MEMORANDUM

To: Planning Commission
From: Leigh Crabtree, Associate Planner
Steven Sparks, Planning Manager
Date: September 18, 2013
Subject: DR2013-0040 LD2013-0004 Canyon Fred Meyer Fuel Center
September 25, 2013 Public Hearing Continuance
Staff Response and Packet

Staff Report

APPLICATIONS: **DR2013-0040 and LD2013-0004 (Canyon Fred Meyer Fuel Center)**

South Bridgeport Village Retail/Office
Tualatin, Oregon

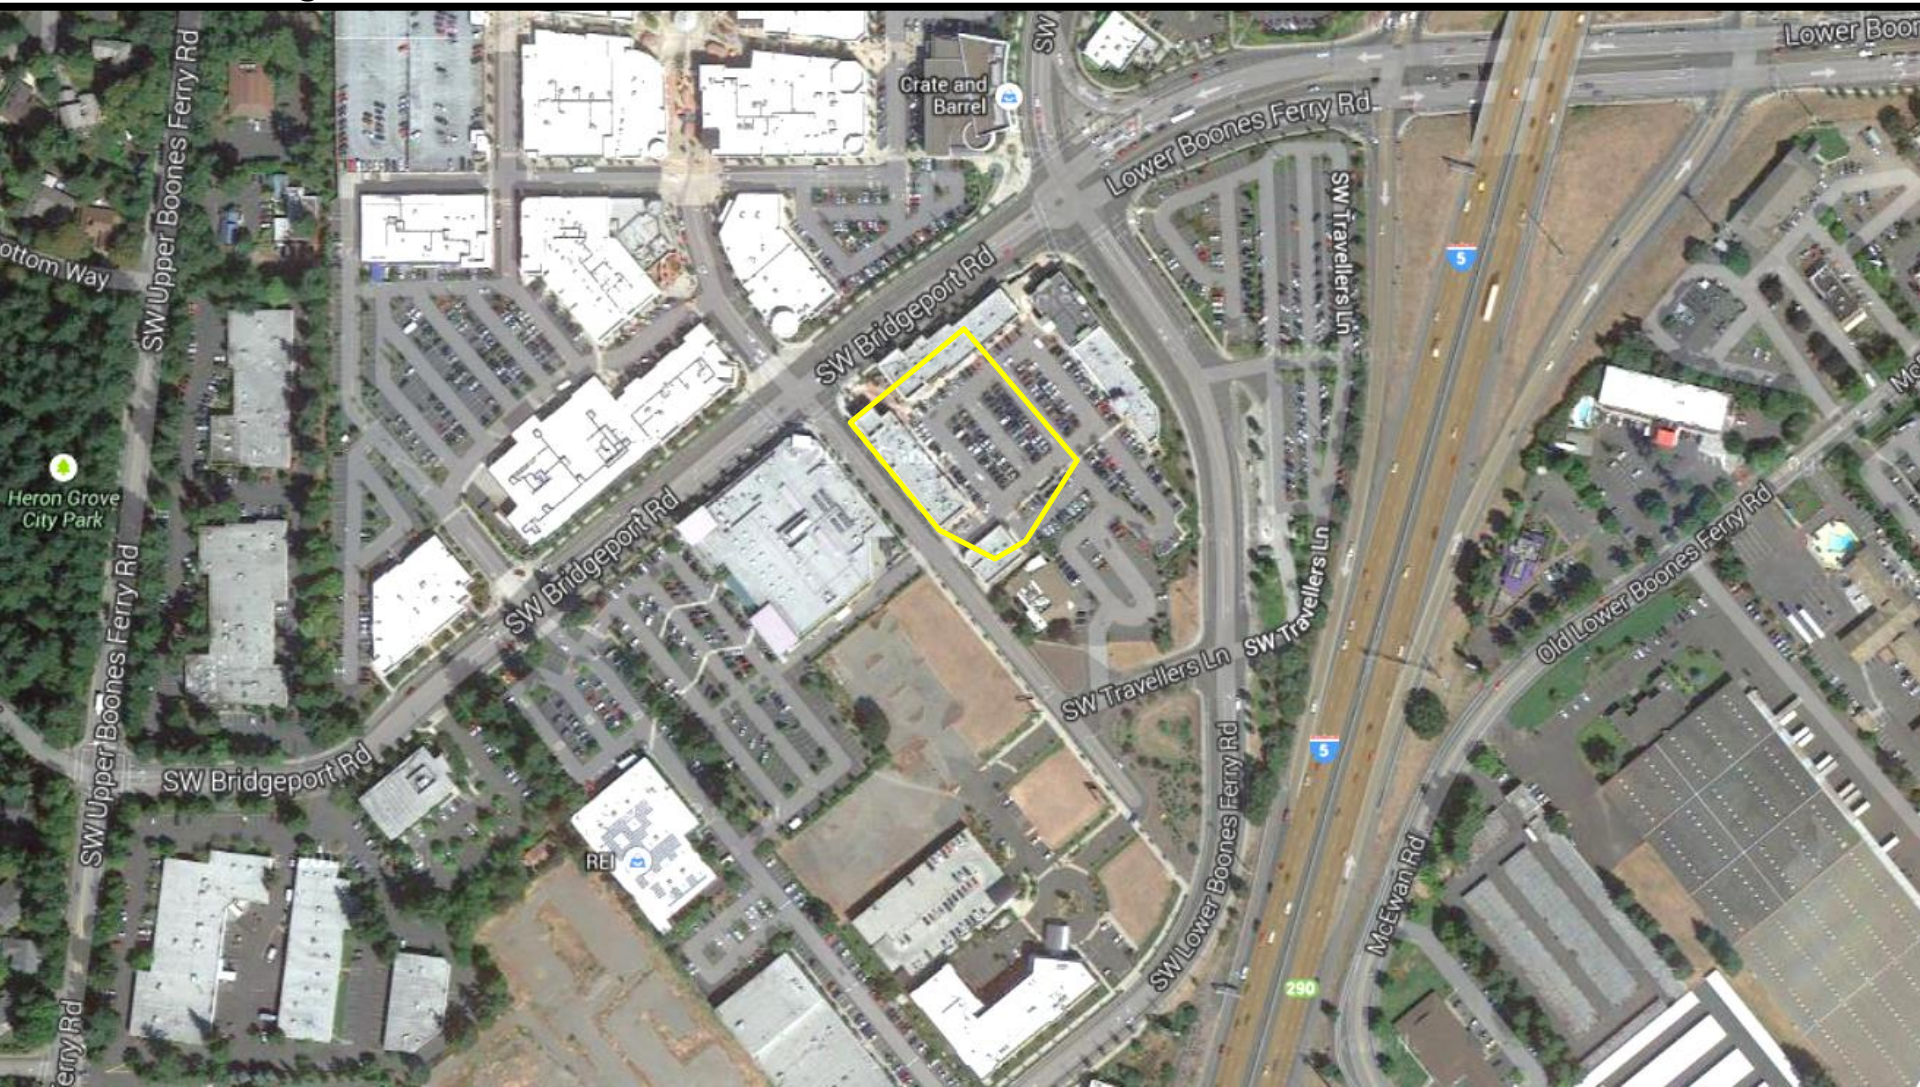
These examples are evaluated with the Design Review Build-out Concept Plan approval criteria. The staff evaluation continues to raise concerns about the realistic ability to construct the proposed Phase II improvements. As a result, staff are not able to make a positive finding to this approval criterion.
